Glen Isla Reserve Coastal Protection Structure
Coastal Engineering Review

Beca Ltd has been engaged by the Western Bay of Plenty District Council (WBOPDC) to review and provide comments on the Engineering Design Report and Assessment of Coastal Processes Report prepared by Davis Coastal Consultants on behalf of Coastal Protection Project for Glen Isla Protection Society (GIPS), for a proposed 200m long rock revetment seawall at Waihi Beach.

Figure 2, Suggested adjustment to the proposed design to reduce impact of the structure on the coastal environment

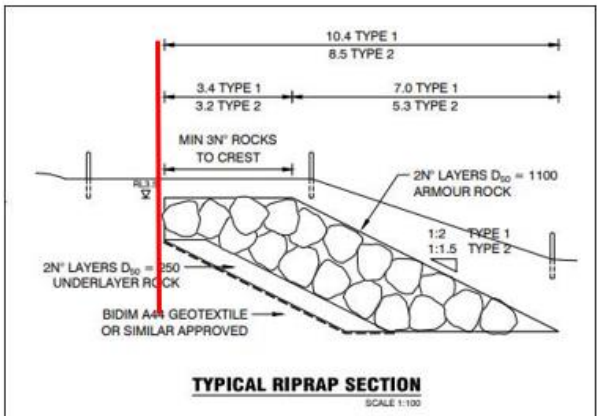
We acknowledge that a hard structure is justified for coastal protection along the Type 1 section, and that the structure is appropriately designed. However we consider that its alignment should be adjusted to comply with the NZ Coastal Policy Statement in that hard structures should be designed to “*minimise adverse effects on the coastal environment*”. Locating the structure at least 5m landward to the property boundary would reduce the impact that the hard structure has on the beach, coastal environment, and end effects on the area to the south.

This can be achieved by removing the 5m corridor behind the structure where fronting properties 12, 14 and 16 to align the back of the structure with the property boundary as shown by the red line in the figure below.
